PARTS & SERVICE NEWS

REF NO.	AA97082
DATE	June 4, 1997

SUBJECT: O-RING SEAL REPLACED

APPLICATION: 210M (BFA-36, 40), equipped with rear axle oil disc brakes

FIG. 15374A
FINAL DRIVE ASSEMBLY

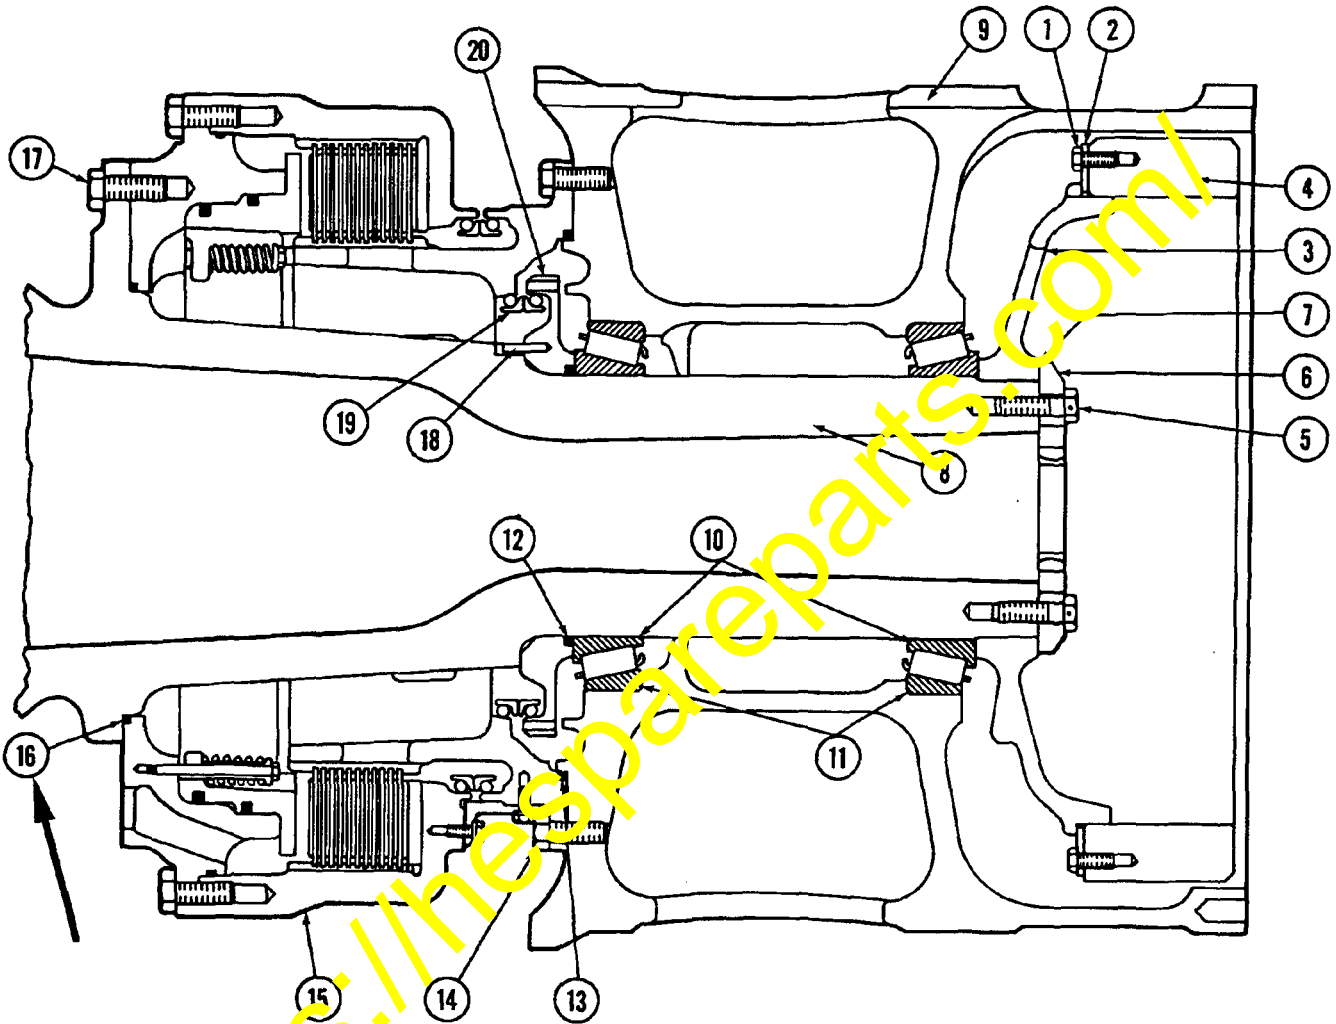
A new O-Ring seal, P/N WA4795, has been introduced for use in the rear axle area of the 210M. This O-Ring - item 16 - Figure 15374A (Pg. 2), replaces WA4789 when used in the applicaiton. The new O-Ring utilizes a seamless design for improved sealing of the oil-cooled brake assembly onto the rear axle.

When installing the new O-Ring, be sure that the mating surfaces of the axle and brake assembly are clean, and free of burrs. The use of a sealant such as "Permatex Aviation Form-A-Gasket #3D" is permissible when installing this O-Ring seal. Use care to prevent this material from entering areas not intended.
